TECHNICAL ZENITH BULLETIN

NO. T-47A

DATE 1-15-51

SUBJECT: ECONOMIZER CALIBRATION DRILL SIZE
for
"J" TYPE* 161 and 67 SERIES CARBURETORS

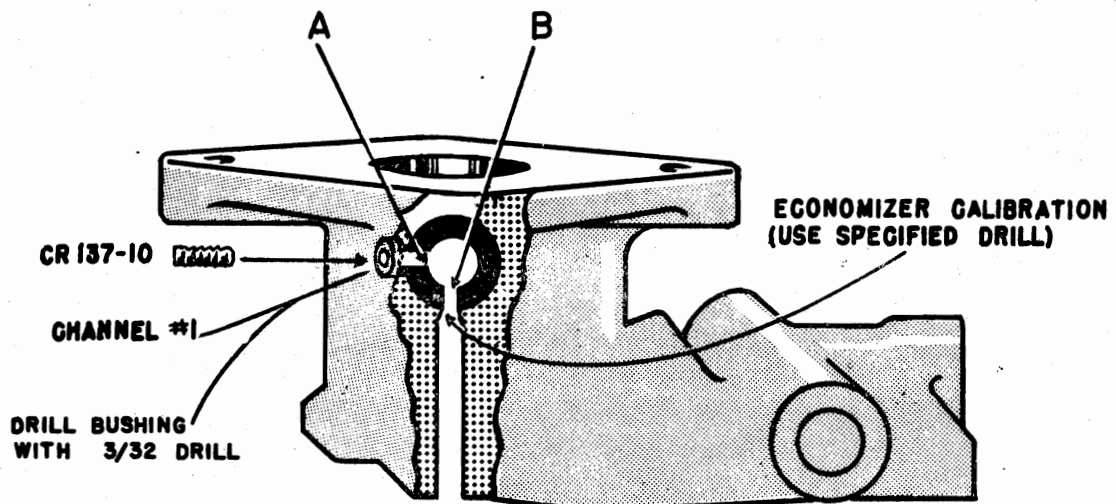
A review of the specifications for all "J" type 161 Series carburetors, supplied to date, indicates that in all but five cases the specified size for the Economizer Calibration is .055".

The five exceptions are: 10697, 10698, 10699, 10902 and 10903. The specified size for the Economizer Calibration for these carburetors is .071".

The above information applies to all "O" numbers up to and including 10913 and all "S" numbers up to and including S1585.

"S" numbers are no longer assigned to carburetor assemblies. Any future assemblies of "J" type 161 and 67 Series will bear regular assembly numbers above 10913. The specifications for the Economizer Calibration of these units will appear in Specification Bulletins, Form No. 534-1, and will be listed as "ECONOMIZER SIZE" with the drill size appearing as the decimal fraction of an inch in the proper column.
